## **ALERT SERVICE BULLETIN**

**407-21-124**

**SUBJECT:** FUEL SYSTEM STANDPIPE ASSEMBLY 407-062-032-103, ONE-TIME INSPECTION AND REWORK OF.

**Figure 1 – Examples of Non-Conforming Internal Welds Joints**

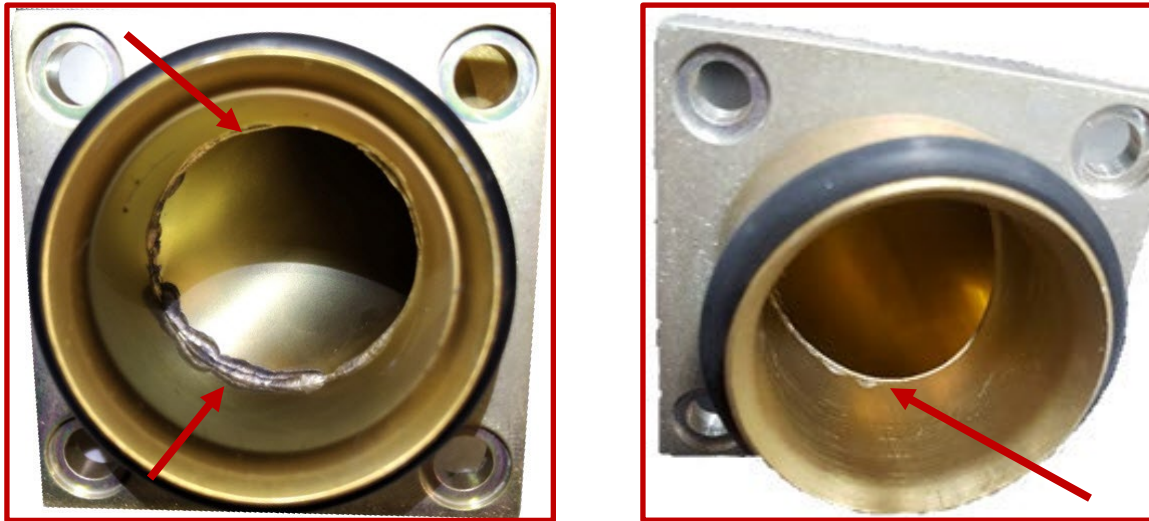
Bell has been made aware of a quality escape from our current supplier of the fuel system standpipe assembly 407-062-032-103. Some standpipes may have been delivered with sharp edges at the internal weld joints (Figure 1). If not corrected, this could lead to fuel quantity system wiring damage and loss of, or erratic, fuel quantity indication.

3. Inspect interior of fuel system standpipe for evidence of sharp edges of the two internal weld joints (Figure 1).
  - a. If no sharp edges are present, go to step 4.

**Figure 2 – Example of Internal Weld Joint After Deburring**

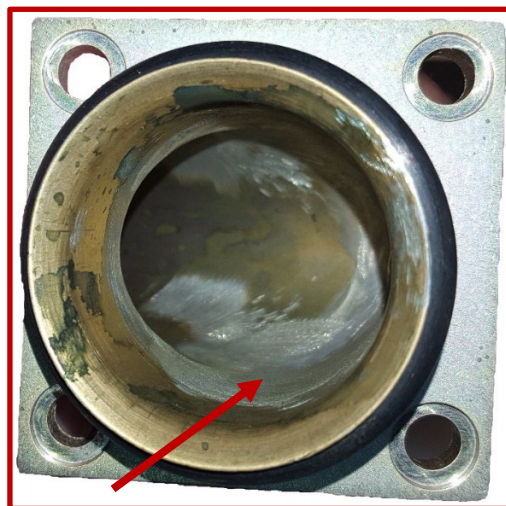
- b. If sharp edges are present, lightly deburr edges of weld joints using aluminum oxide abrasive cloth or paper (commercial) (Figure 2). Make sure not to exceed 0.015 inch (0.38 mm) depth into the tube material at a 45 degree angle to the weld joints.

- c. Using a clean cloth (C-516) dampened with isopropyl alcohol (C-385), remove all sanding residue.
  - d. Touch up bare metal surfaces with chemical film material (C-100) (BHT-ALL-SPM, Chapter 3, and Paragraph 3-16). Go to step 4.
